October 15, 2019

## **Georgia Power Company**

### **Preliminary Analysis of Closure Permit Applications and Federal and State CCR Compliance for the Sierra Club**

**Plants Bowen, Hammond, McDonough, Scherer, Wansley and Yates**

**Figure 1 – Plant Bowen**

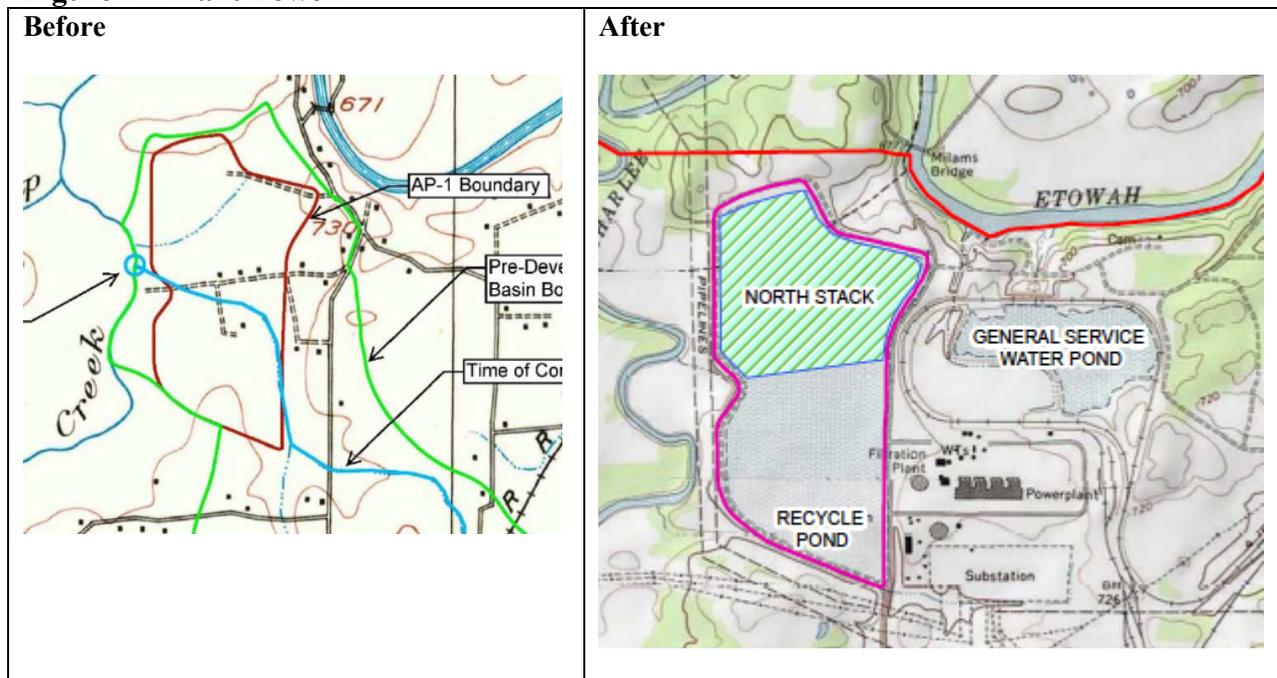
Georgia Power vertically expanded impoundment AP-1 at Plant Bowen in 1992 and 2001 by placing “dry” CCRs on top of wastes in the former unlined impoundment. This disposal method is referred to as a “dry stack.” The dry stack at Plant Bowen, illustrated on **Figure 1**, is discussed later in this analysis.

Georgia Power’s surface impoundments were constructed over existing streams at Plants Bowen, McDonough, Wansley, Scherer, and Yates. Georgia Power also constructed impoundments adjacent to large rivers and small streams, as illustrated in **Figures 1** through **6** below. At Plant Bowen, Georgia Power constructed the 254-acre impoundment AP-1 (note the vertically expanded “North Stack”) over an un-named tributary of Euharlee Creek (blue line within the red area, left diagram) and near the Etowah River, as illustrated in **Figure 1** below.<sup>41</sup>

**Figure 5 – Plant Scherer**

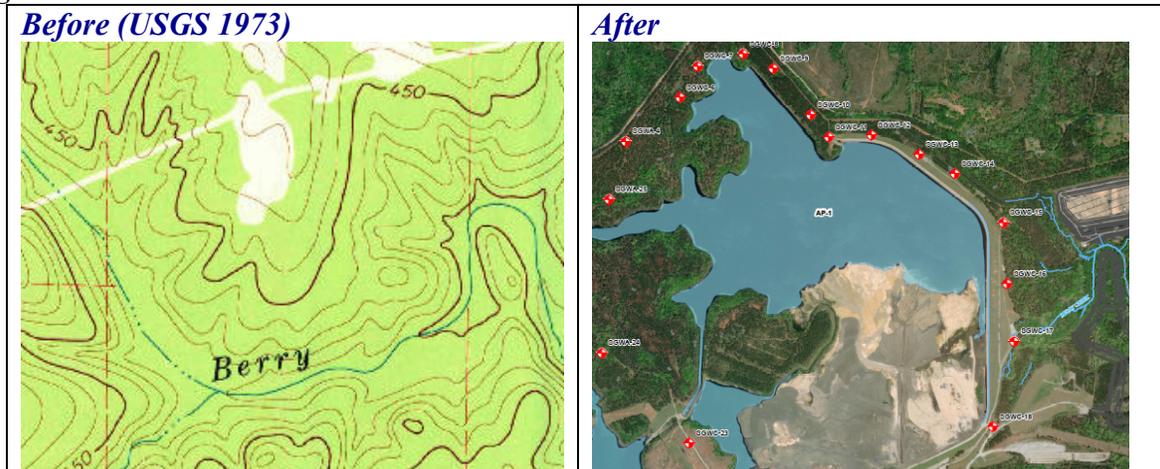
- **Plant Scherer** – groundwater elevations after closure of AP-1 will range from 440 to 490 feet above mean seal level.<sup>60</sup> When those elevations are compared to the pre-filling ground topography (**Figure 4**) that ranged from 410 to 450 feet in the same area, the data indicates that approximately 30 to 40 feet of CCRs will remain submerged in the former stream valley after closure is complete.
- **Plant Wansley** – a diagram included in the Closure Plan illustrates that at least 75 feet of CCRs will remain submerged in the former stream valley post-closure. In fact, the elevation of groundwater within the CCRs is the same as the water elevation that will remain standing in the adjacent pond.<sup>61</sup> The planned concrete pile wall will not prevent water from the adjacent pond from intermingling with and saturating CCRs in the closed-in-place area.

Figure 8 - Plant Bowen (2019 Report, Figure 3, note radial mounding)

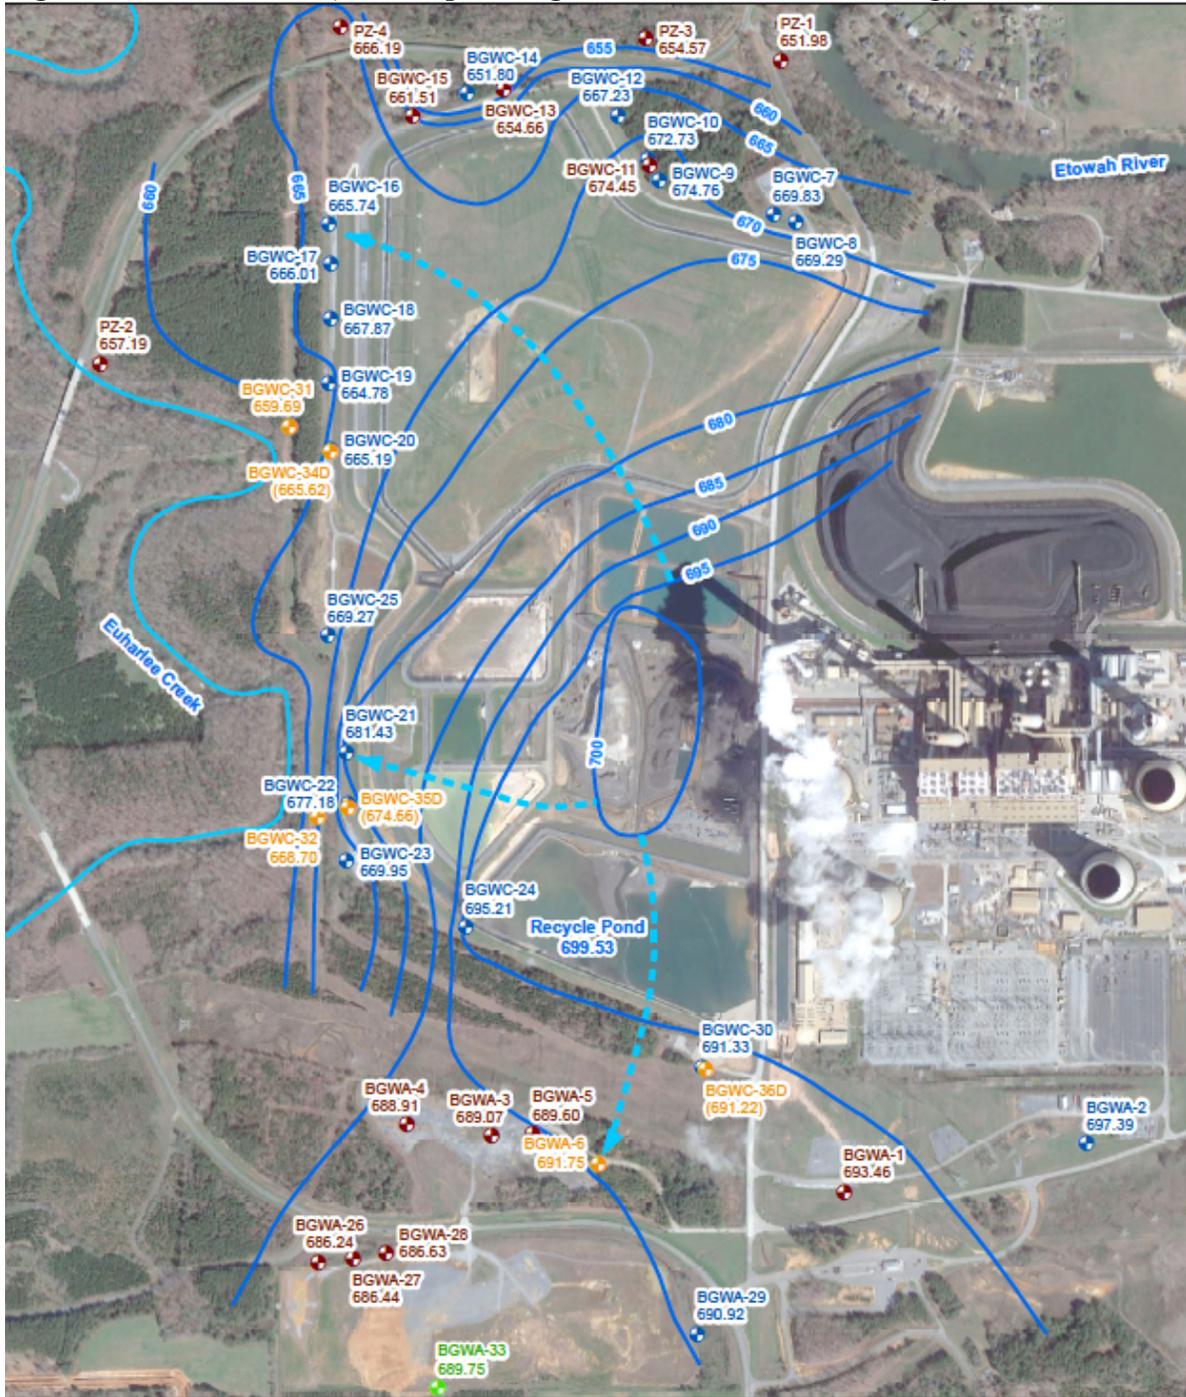
- **Plant Bowen** – the highest concentrations of calcium, chloride, sulfate, and total dissolved solids were reported in wells with shallower screen intervals: BGWC-22, 23, and 24 (see **Figure 8**).<sup>54</sup> Those wells are isolated to the southwest corner of the impoundment.

Figure 9 - Plant Hammond (2019 Report, Figure 3)

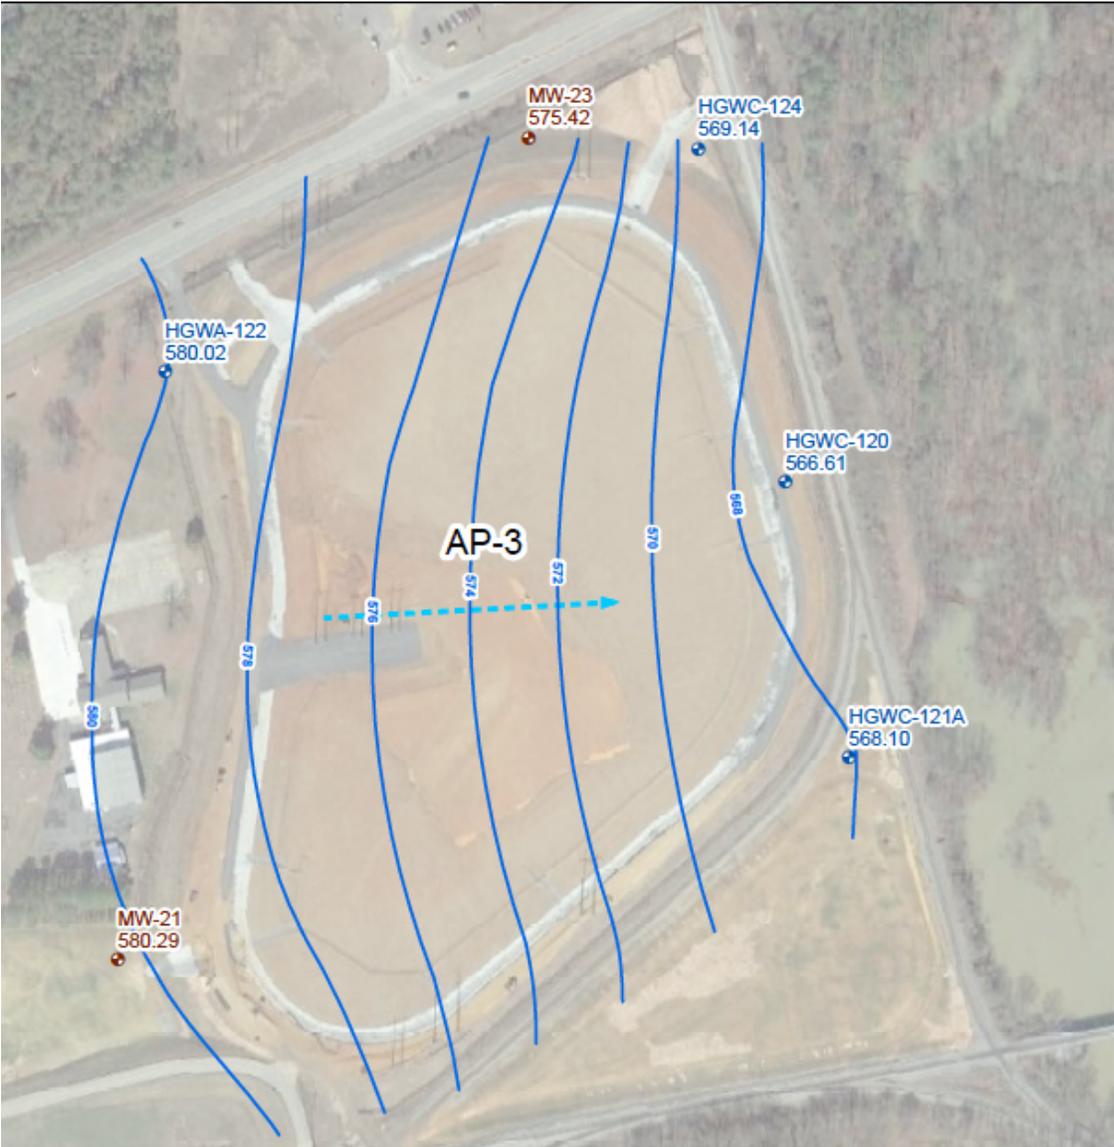
- **Plant Hammond** – the highest concentrations boron, calcium, chloride, sulfate, and total dissolved solids were in the downgradient well with the shallower screen interval: HGWC-121/121A (see **Figure 9**).<sup>55</sup>

Figure 12 - Plant Wansley (2019 Report, Figure 3)

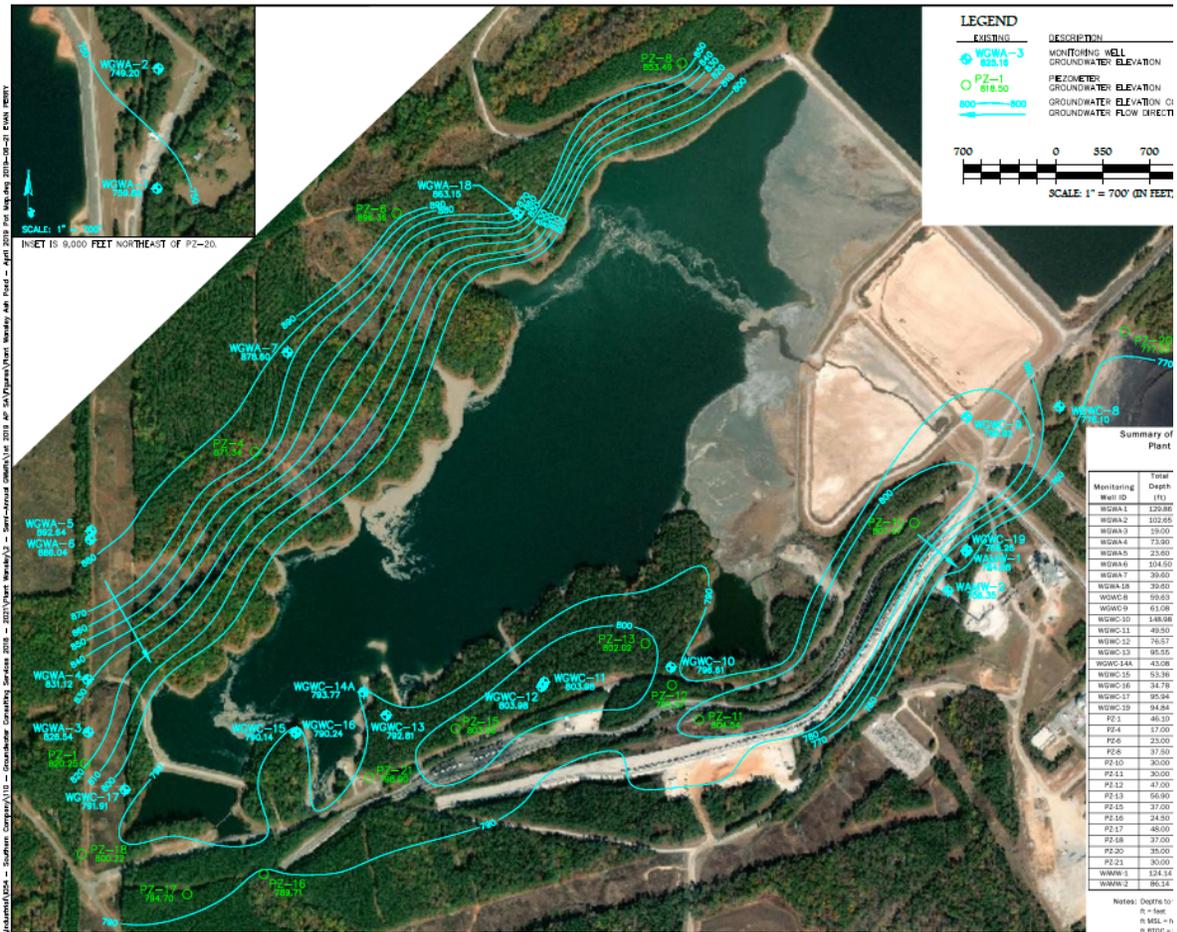
- **Plant Wansley** – the highest concentrations of boron, calcium, chloride, sulfate, and total dissolved solids were in the well with the second shallowest screen interval: WGWC-16 (see **Figure 12**).<sup>56</sup>

**Figure 13 - Plant Yates (2019 Report, Figure 3)**

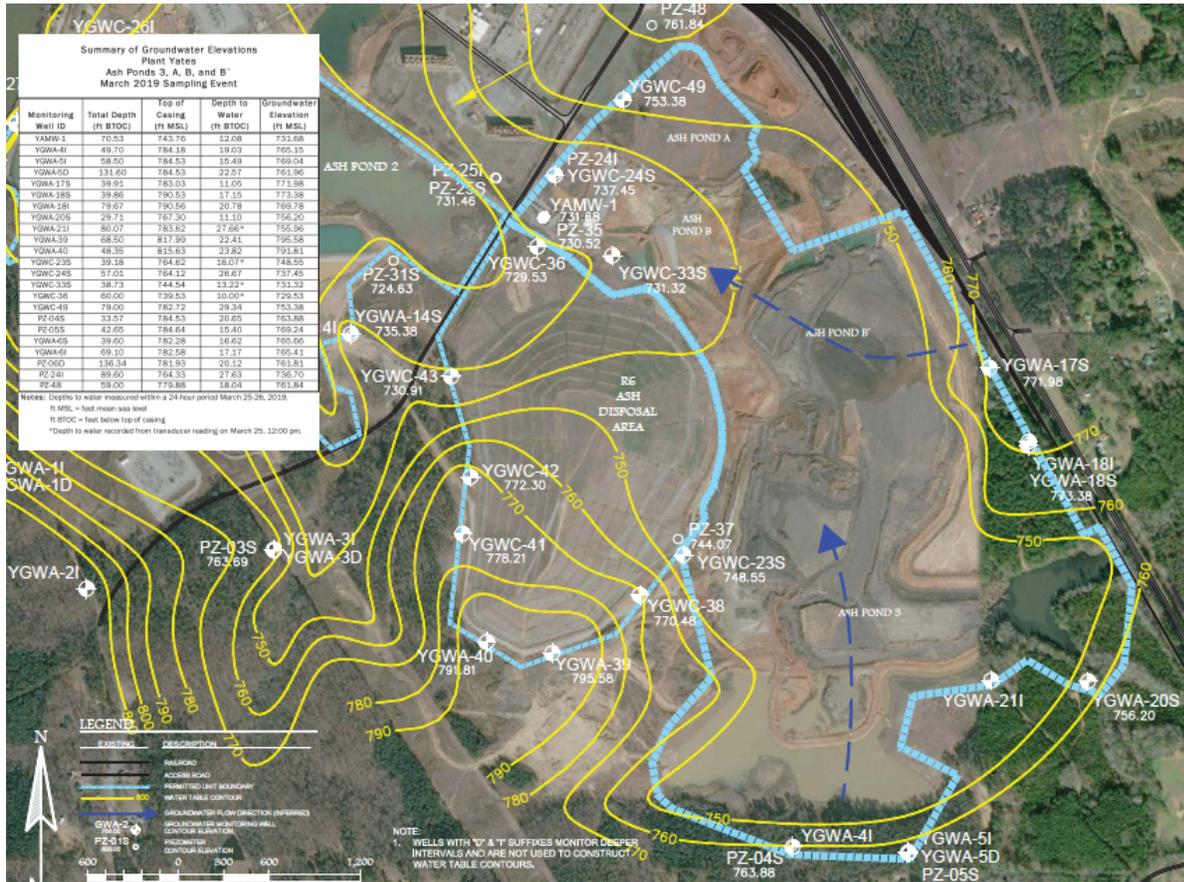
- **Plant Yates** – the highest concentrations of boron, calcium, chloride, sulfate, and total dissolved solids were in the well with the shallowest screen interval of the most downgradient wells: YGWC-33S (see **Figure 13**).<sup>57</sup>

**Figure 15 - Plant Hammond**

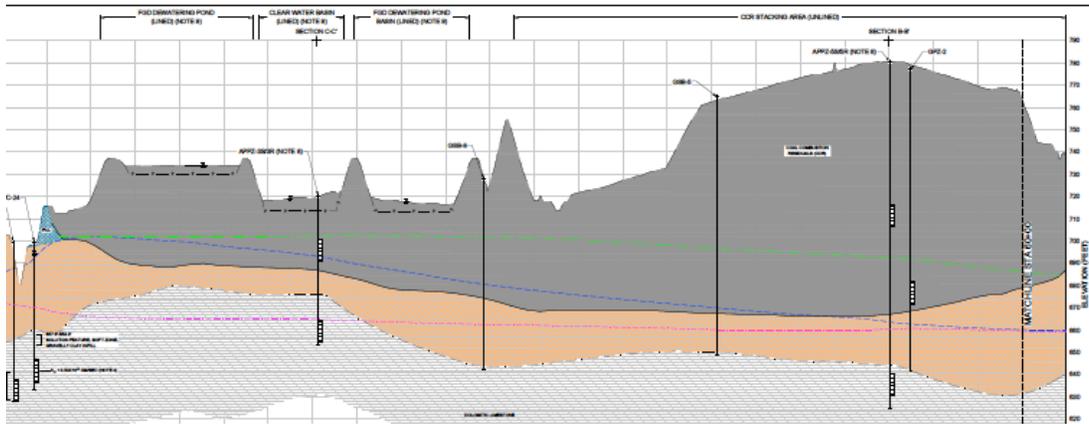
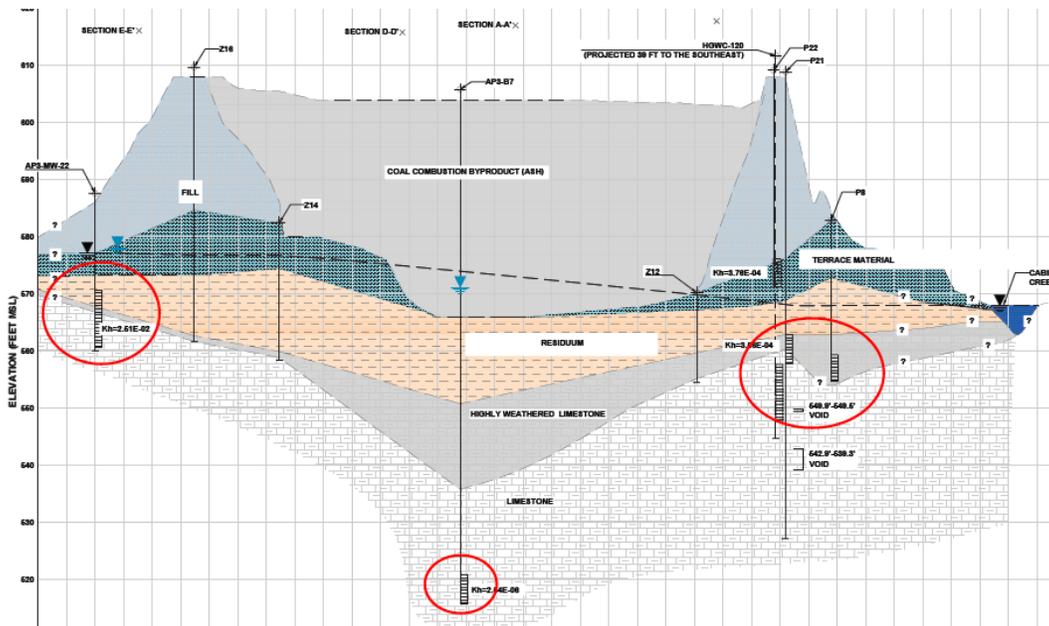
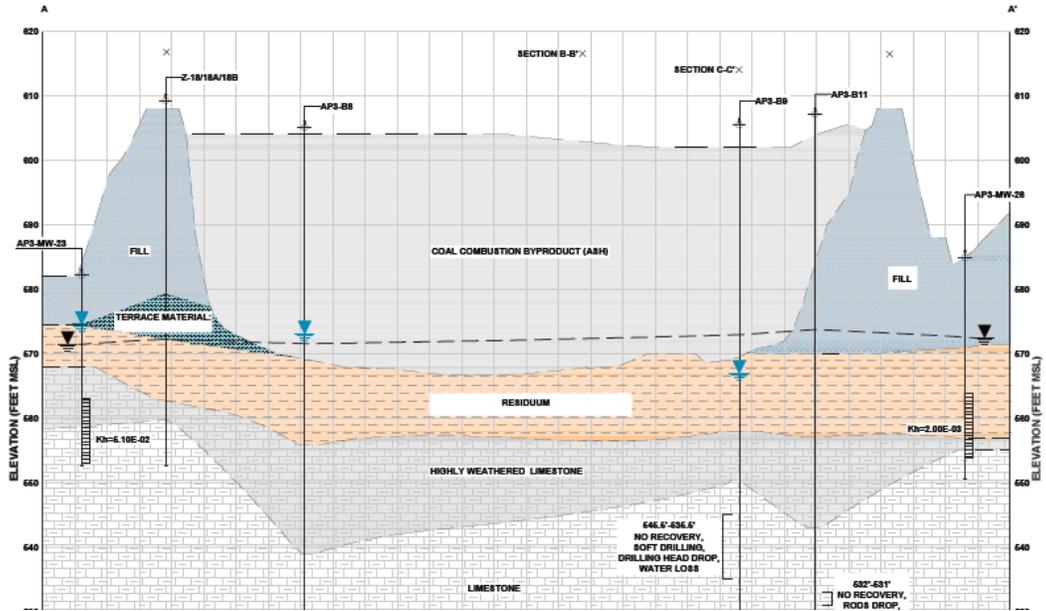
CCRs in surface impoundments have been submerged in groundwater in the uppermost aquifers. Reports prepared on behalf of Georgia Power (Part B Applications, Hydrogeologic Assessment Report, each Plant) describe and illustrate CCRs that are submerged in the uppermost aquifer (depicted by the dashed line and blue triangles on each figure) at Plants Bowen, Plant Hammond, Plant Scherer, and Plant Wansley, as illustrated in **Figures 14 through 18**.

- **Plants Bowen and Hammond** – **Figures 14** and **15** illustrate how the wells are screened in bedrock; they are much deeper than the top of the water table aquifer in soil; they miss groundwater that flows from the impoundment and through the dike, and there are no wells to measure the quality of groundwater that discharges into the adjacent creeks.
- **Plant Scherer** – **Figure 16** illustrates how wells are drilled into soil; however, the wells were screened much deeper than the top of the water table aquifer.
- **Plant Wansley** – **Figure 17** illustrates piezometers within the CCRs (grey area) and how well WGWC-19 is screened approximately 100 feet deeper than the top of the water table aquifer.
- **Plant Yates** – **Figure 18** illustrates how much deeper soil wells are screened compared to the surface of the water table.

**Figure 19 – Plant McDonough Groundwater Cutoff Wall**

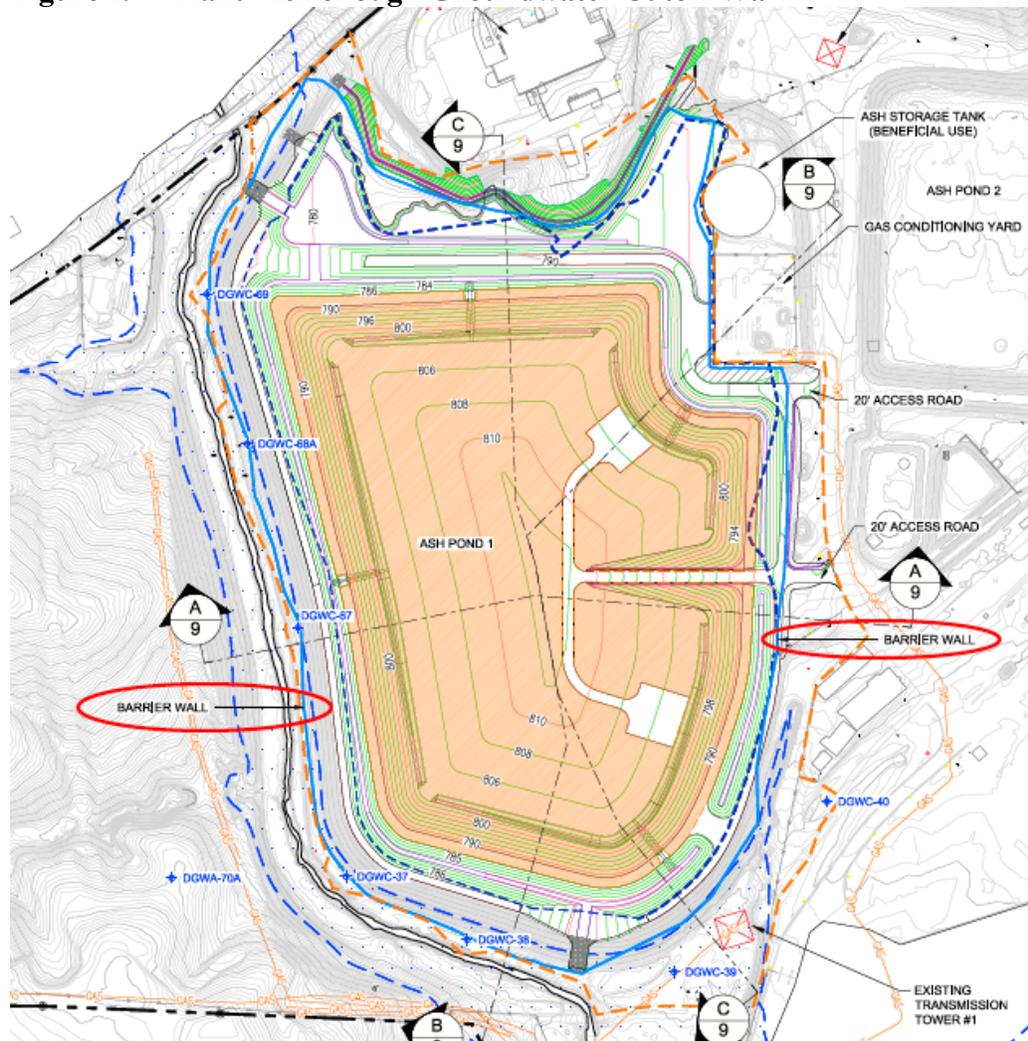
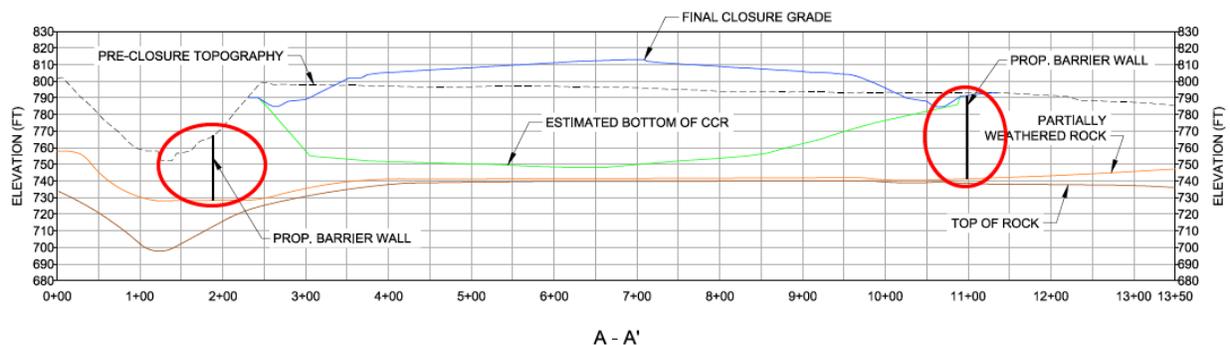
In an apparent attempt to capture contaminated groundwater from an unlined surface impoundment, Georgia Power included a conceptual layout of a groundwater cutoff wall (i.e. perimeter barrier wall) for impoundment AP-1 at Plant McDonough (**Figure 19** below). Georgia Power failed however, to include any such system at other impoundments at Plant McDonough or any other Plant evaluated in this analysis.<sup>62</sup>

The planned construction of a groundwater cutoff wall for impoundment AP-1 at Plant McDonough and not elsewhere creates unexplained disparity with Georgia Power’s decision-making—with other Plants even being located within more environmentally sensitive areas (e.g. Most Significant Ground-Water Recharge Areas) than Plant McDonough.
